# SLIM CHICKENS SITE PLAN

PARKER AND PINE FILING NO. 1, LOT 3

Line denotes acknowledged Changes made by applicant on this Review 03 dated 4.9.21  
 Blue cloud denotes new comment on this Review 03 dated 4.9.21

### TOWN OF PARKER PLAN REVIEW

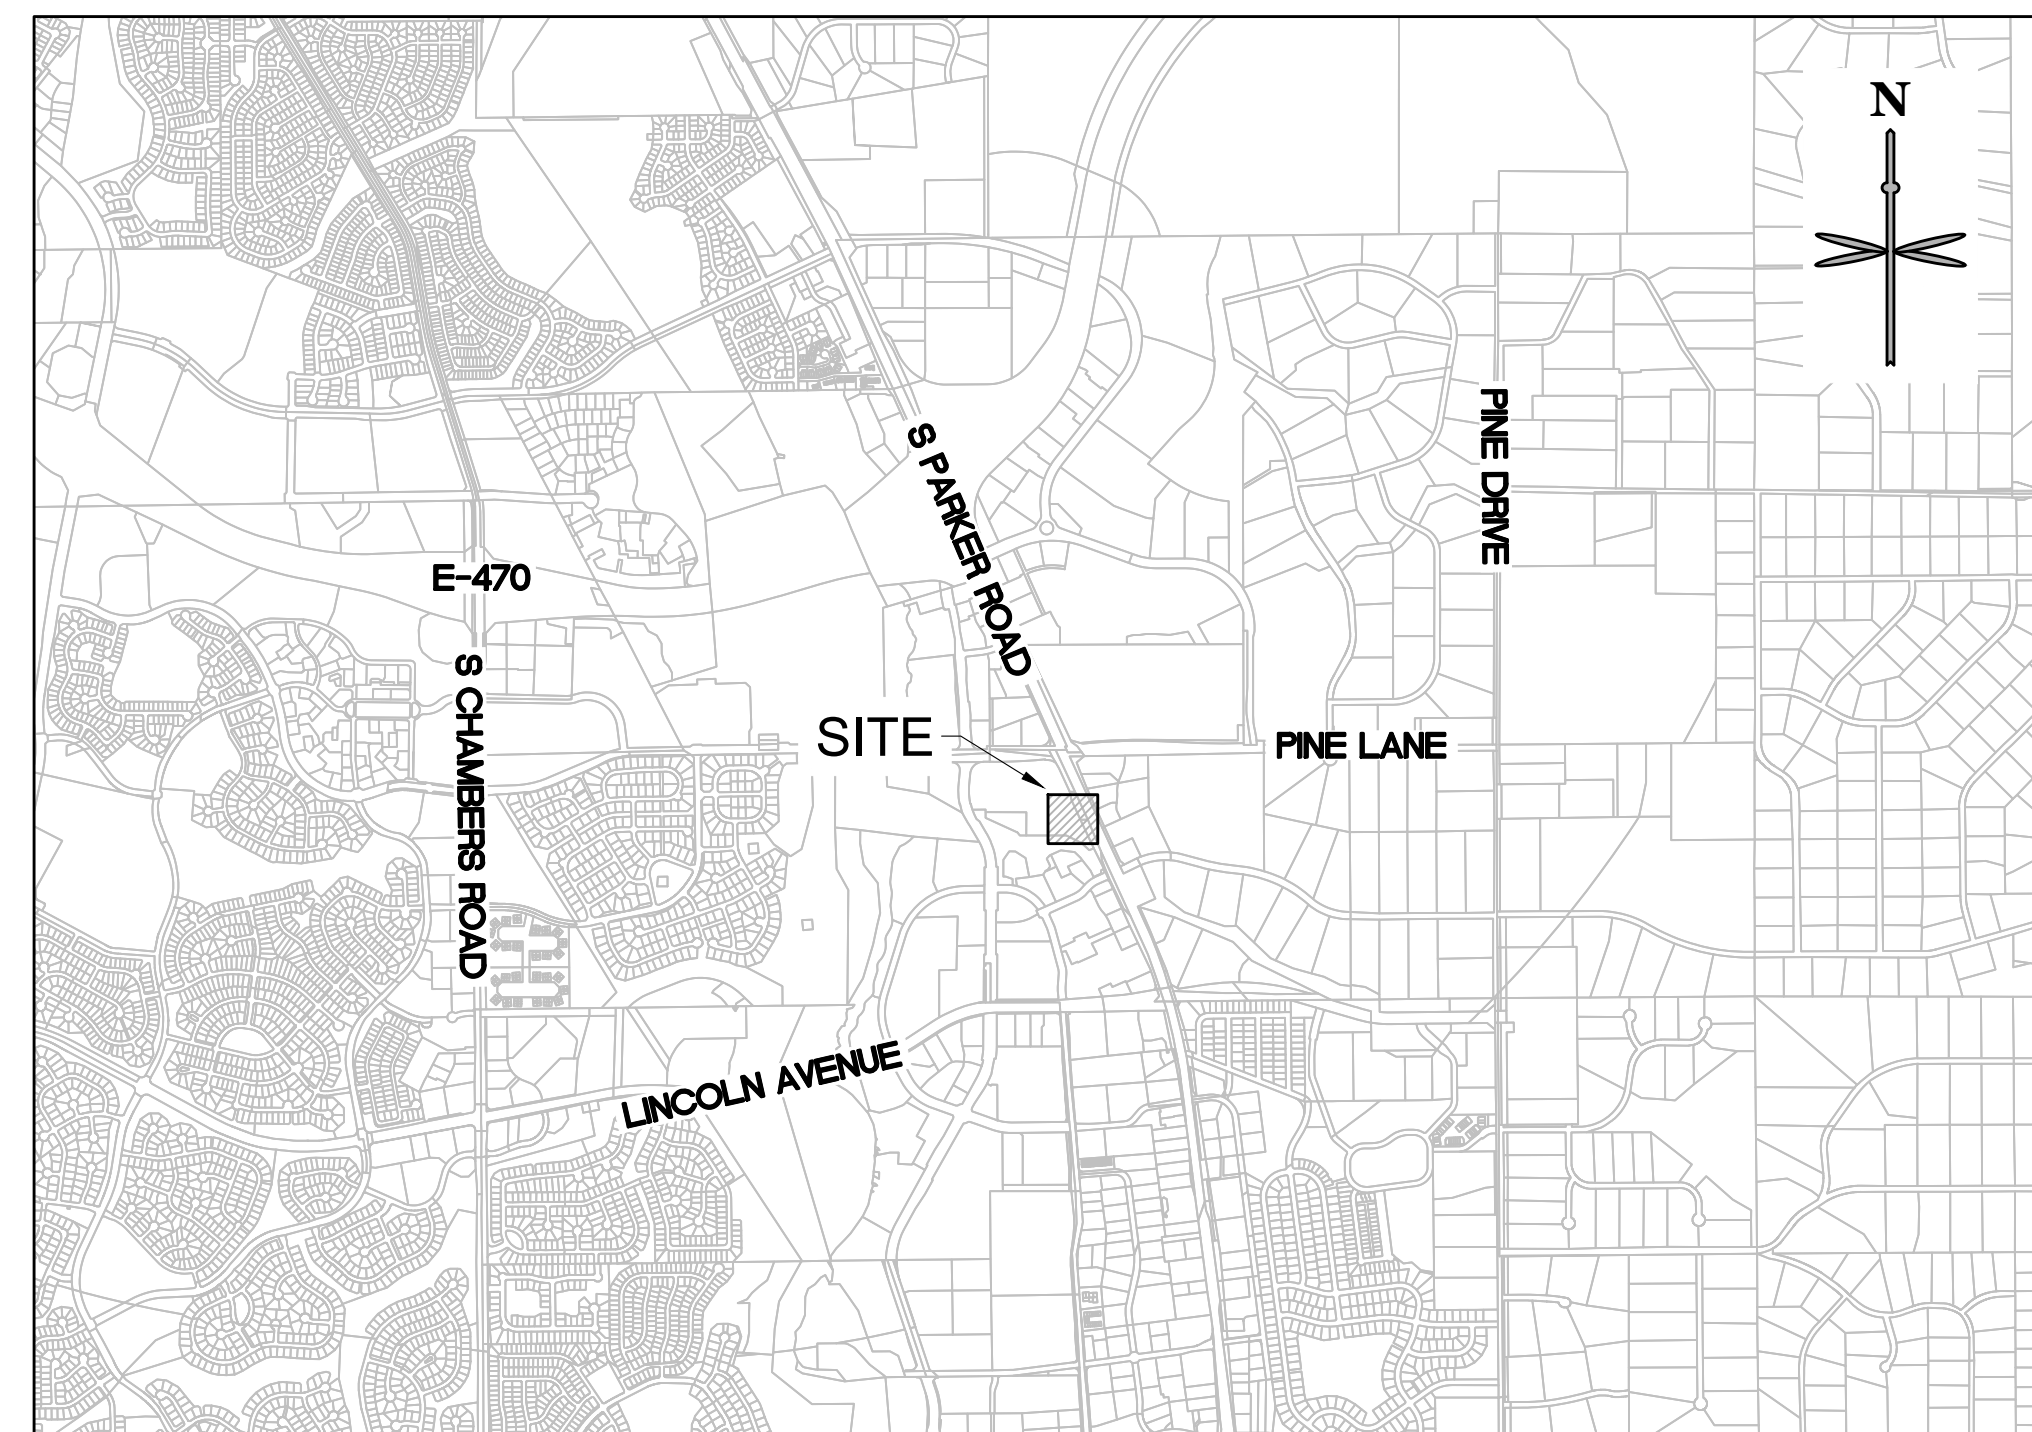
**COMPLETED.**  
 Add Setbacks, Required & Proposed for front/W elev., rear & sides to the table.

SITE PLAN	DATE	
	BY	
SLIM CHICKENS	REVISION	
	No.	
SITE PLAN		
	SWC OF S. PARKER ROAD AND E. PINE LANE, PARKER, CO 80134	
PROJECT NO.:		TSD003.01
DESIGNED BY:		CAM
DRAWN BY:		JLG
DATE:		03/30/2021
<b>C1.0</b>

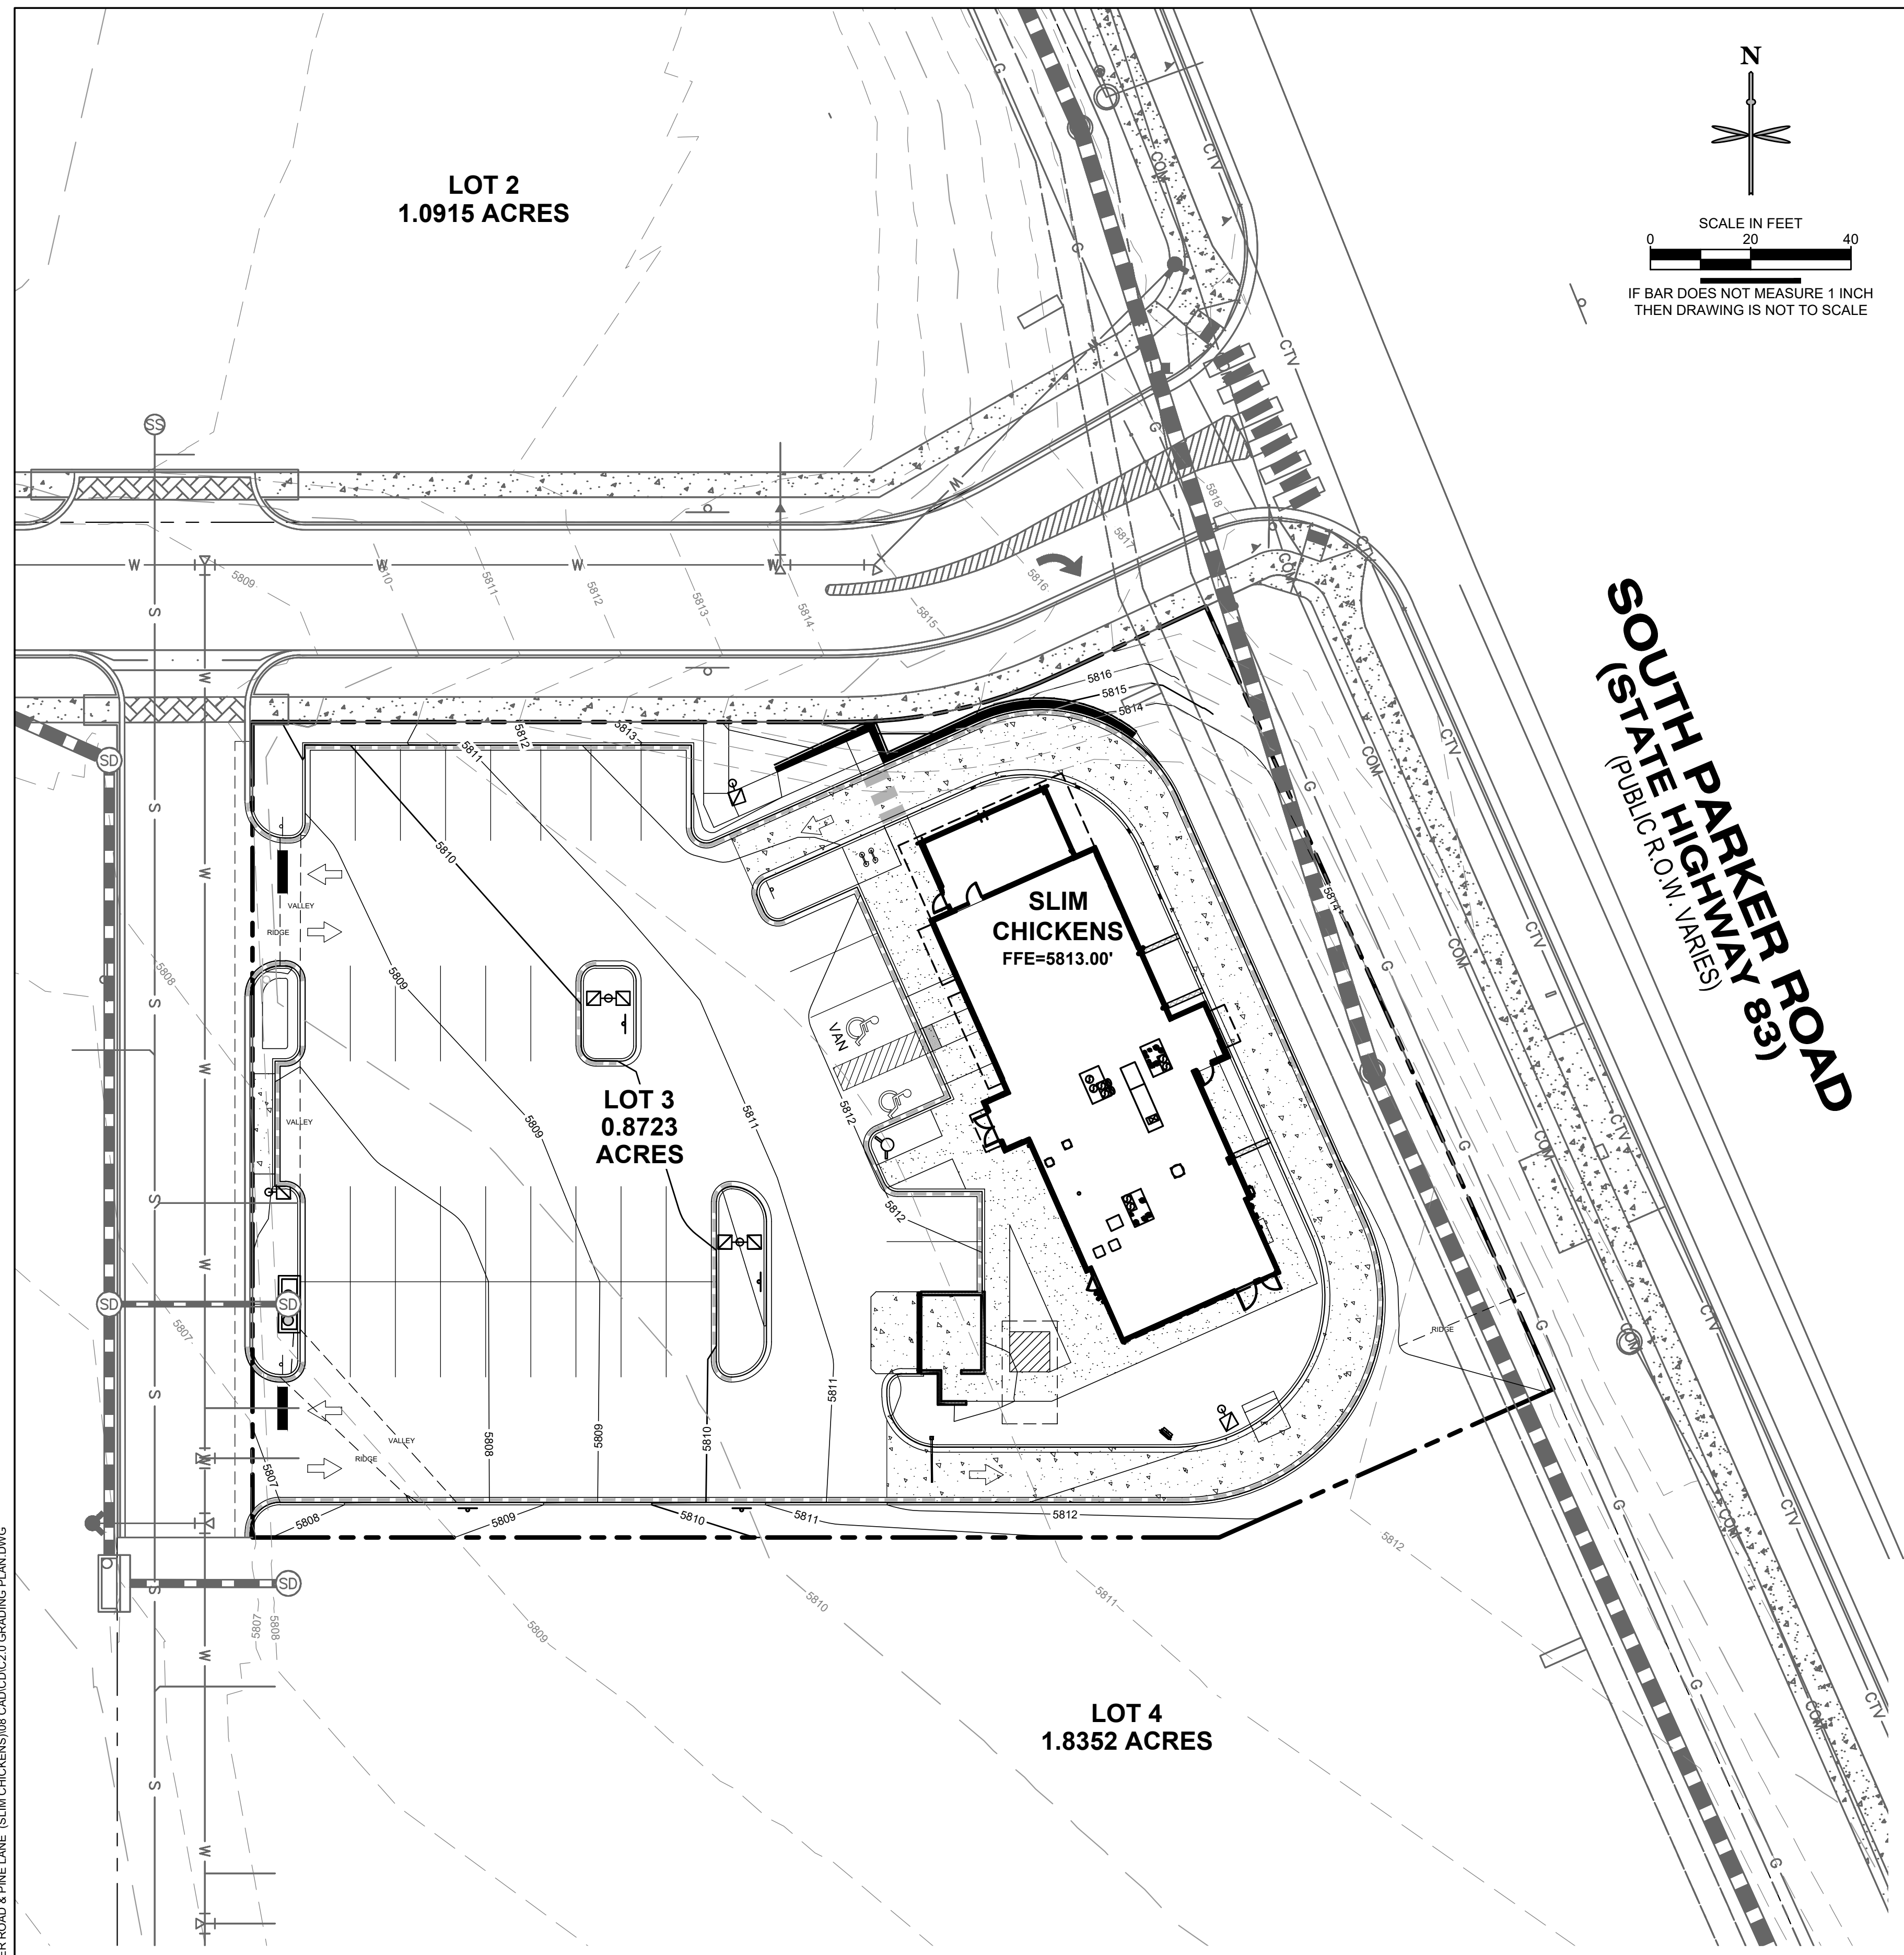
**RETAINING WALL. NOT NEEDED THIS FAR.**

Extend landscape wall to this corner point of building. Provide drawings/illustrations/details

Please add sidewalk dimension on site plan

Please add wheel stops for head-in parking at building

Please label as concrete sidewalk & add dimensions

-Please provide exact block material/color & fence proposed for approval of this landscape wall.  
-Add drawing/graphic to site plan or elevations with details including dimensions.

**ADDED.**

**ADDED.**

**PLANS IN CD SET.**

SITE PLAN SLIM CHICKENS PLANTING PLAN  
 SWC OF S. PARKER ROAD AND E. PINE LANE, PARKER, CO 80134

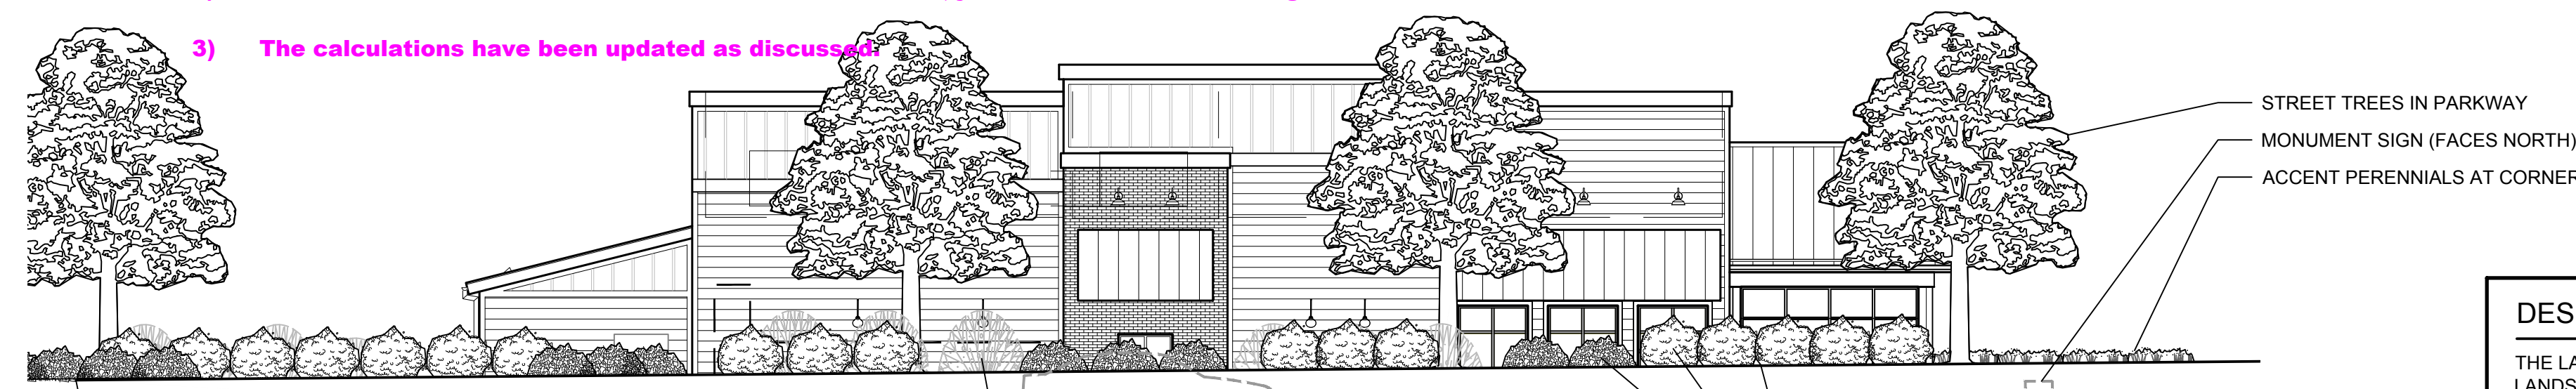
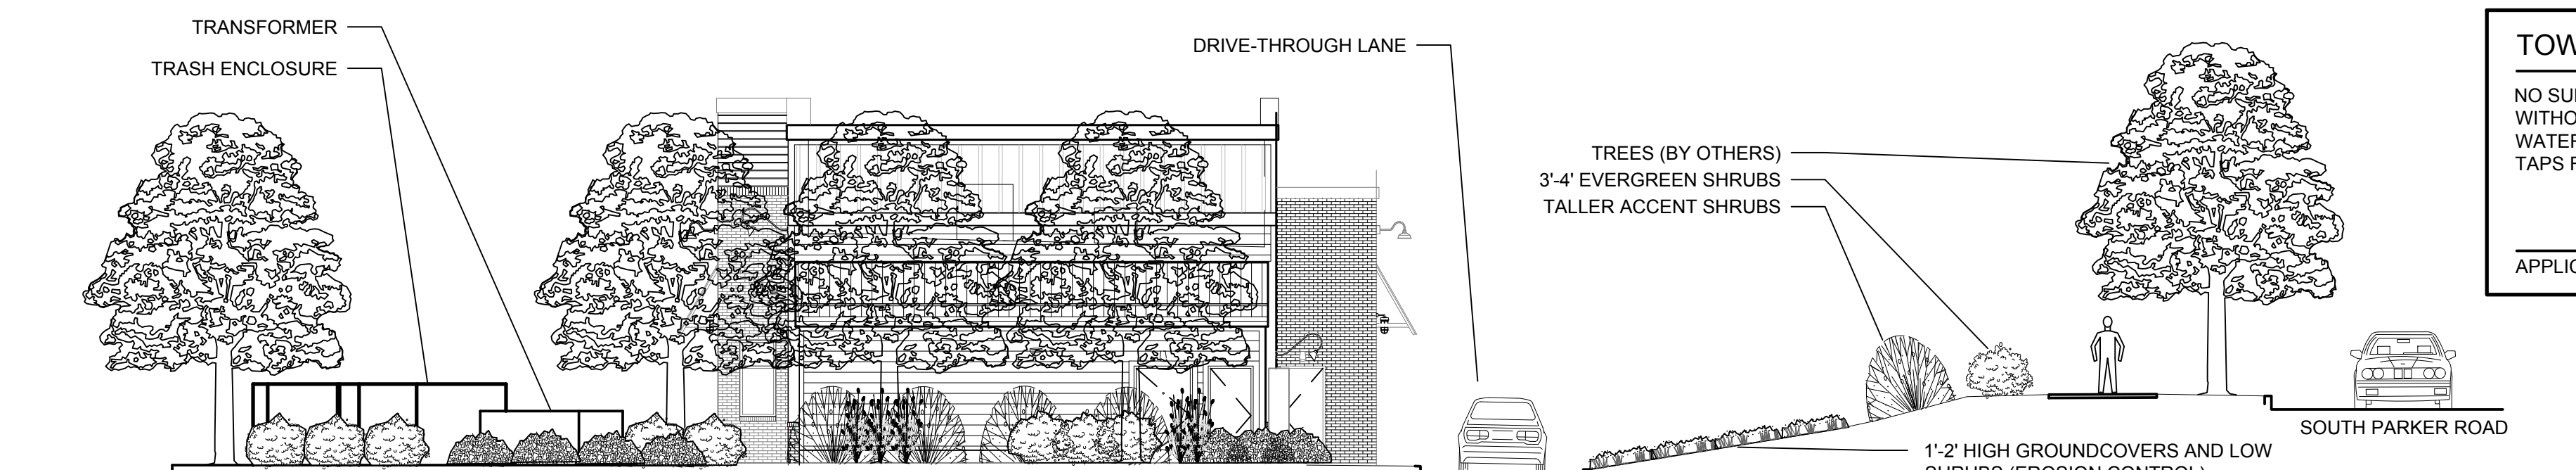
RETAINING WALL NOT NEEDED THIS FAR.

Extend Landscape wall around to this original location.

Add shrubs back on N side of walkway to soften & balance out.

Per LDO/code section 13.06.070 (I)(5)(c.) Minimum Site Landscaping Standards: "A mix of deciduous and evergreen trees is required to provide color and screening in winter months. A minimum of twenty-five percent (25%) and a maximum of fifty percent (50%) shall be evergreen trees."

- Per agreement, two 'Marilee' crabapples have been added to the north side of the parking area.
- One more 'Morton' elm has been added on the east side, just east of the drive-through lane.
- The calculations have been updated as discussed.
